Mr James Appleton: case officer AWDM/0961/17
Adur and Worthing District Councils
Development Management
Portland House
44 Richmond Road
Worthing, West Sussex
BN11 1HS

AWDM/0961/17 Land East Of Shadwells Road At Mash Barn Estate Mash Barn Lane Lancing West Sussex (the 'New Monks Farm' site)

This letter includes the attached / enclosed **Non-Motorised Users Design Review** which forms the evidence base of our objection.

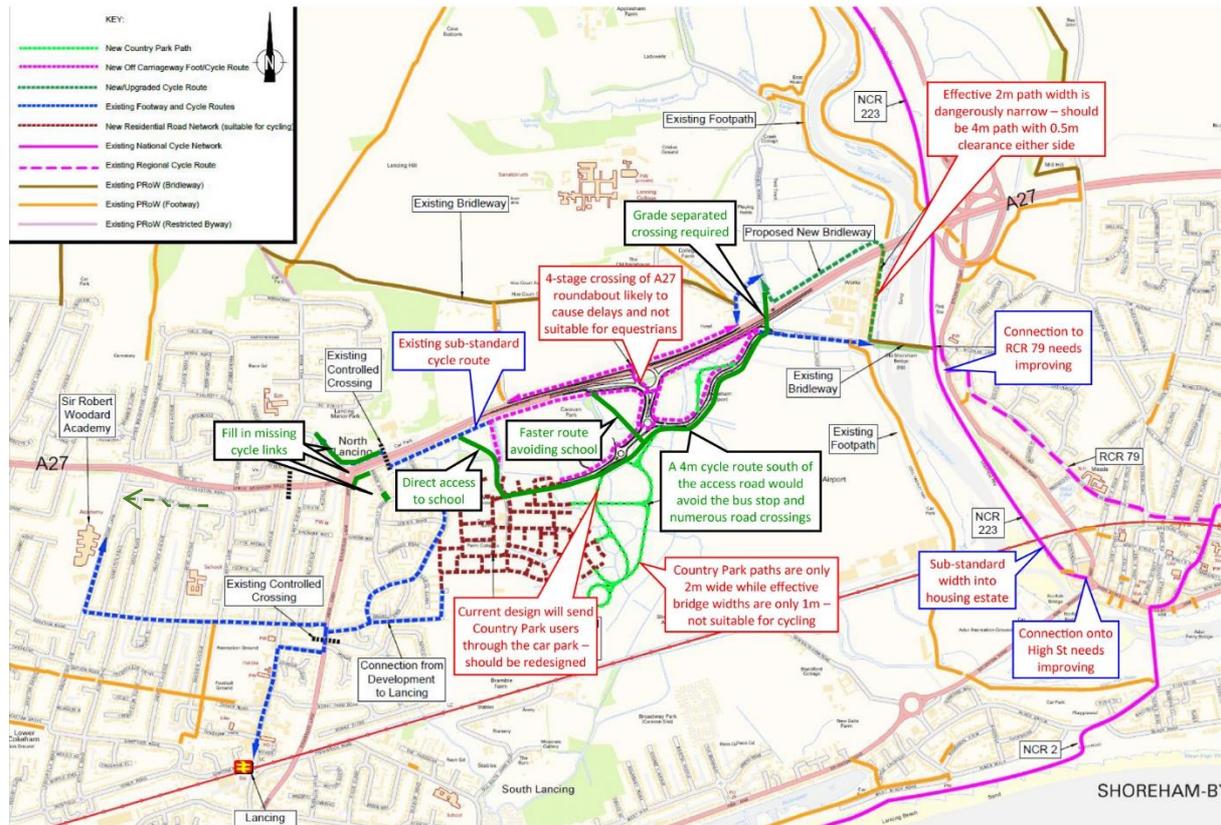
We **object** to the replacement of the Sussex Pad crossing with proposed pedestrian and cycle crossings at the proposed roundabout which forms the entrance to the proposed development site and we object to the failure of the proposed development to propose a high-quality network of routes for pedestrians, equestrians and cyclists through the proposal site and linking with neighbouring areas which, as pointed out in the WSCC third response dated 23rd January 2018, also introduces a large number of crossings which will make walking and cycling less convenient and unnecessarily exposes users to junction risks.

- The proposals as they stand are contrary to the National Planning Policy Framework (2012) with regard to the requirement (where practicable) to *'give priority to pedestrian and cycle movements'*. They are also contrary to Local Plan Policy 5 which states the need for *improved* walking, cycling and equestrian infrastructure associated with the New Monks Farm site, and Policy 28 and its supporting text which states that, in general, *"The pedestrian and cycle network ... is indirect, disjointed in parts ... Equestrians and vulnerable users, including those with mobility difficulties, also need to be taken into account"*. This statement shows that the planning authority recognises the scope for improved infrastructure along the A27. Other objections, notably that from the British Horse Society whose letters of February and June 2018 also repeat their requirement for a higher standard of infrastructure design which is currently insufficient to meet the requirement for equestrian infrastructure as set out in Local Plan Policy 5.

- A revised active travel network centred on a new spine cycle track and adjacent footway constructed to the south of the proposed access road network to provide direct, convenient and high-quality links with fewer road crossing points between Old Shoreham Toll Bridge and Manor Road, connecting with the existing residential area and providing a branch to a retained Sussex Pad crossing;

- The conversion of the existing signalised crossing immediately east of the A2025/A27/Manor Road roundabout junction to a shared or parallel cycle/pedestrian crossing together with associated segregated use two-way cycle track on the northern side of Old Shoreham Road connecting, at a safe place, to Manor Road, with safe, flush transitions to the cycling infrastructure to and from the existing roundabout; and

- Provision of a cycle connection between Manor Way and Hayley Road and conversion of the existing footpath link from Orchard Way to Curvins Way to a shared use cycle and footpath link.

- The applicant must submit to the Local Planning Authority in the S.106 and, where applicable, the s.278 Agreements a revised set of proposals showing an active travel network following the recommendations in the accompanying report that demonstrates with reference to Local Plan Policies 1, 5 and 28 and NPPF 2012 paragraph 35 the prioritisation of access for people travelling on foot, cycle and as equestrians. This network must include the following:
